THE WARNER AIRCRAFT CORPORATION
20263 HOOVER AVENUE
DETROIT 5, MICHIGAN

SERVICE LETTER A-18

To all owners of Warner Super-Scarab, Series 40, 50 and 50A, 145 h.p. engines.

SUBJECT: I - Recognition of reinforced taper crankshafts
II - Availability of new heavier stem exhaust valve

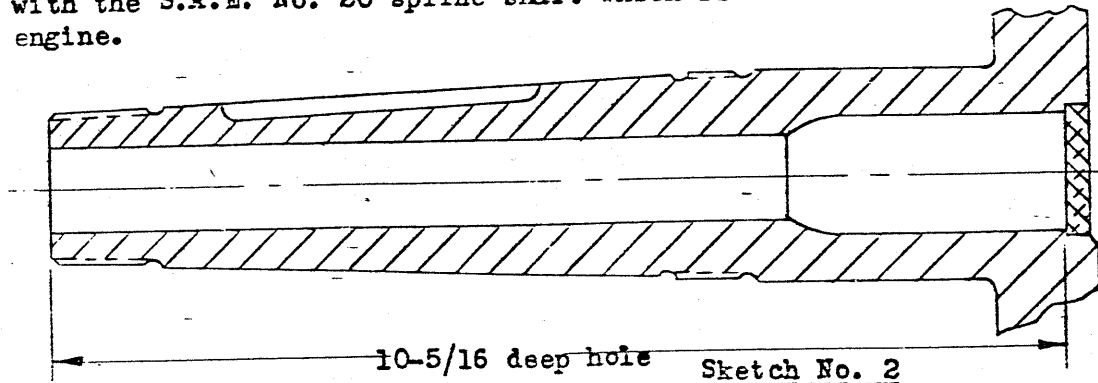
1. (a) The following sketch No. 1 gives the outline of dimensions by which the latest type reinforced tapered crankshaft can be easily recognized. Crankshafts of this type are not subject to the periodic inspection outlined in Service Letter A-7 and C.A.A. Airworthiness Maintenance Bulletin No. 15, dated November 22, 1939.

- (b) Crankshafts of the type shown below in Sketch No. 2 are the Non-reinforced crankshaft and the periodic inspection referred to in Paragraph 1.(a) must be complied with. It is strongly recommended that crankshafts of this type be replaced, either with the reinforced shaft shown in Sketch No. 1, or with the S.A.E. No. 20 spline shaft which is standard on the Series 50A engine.
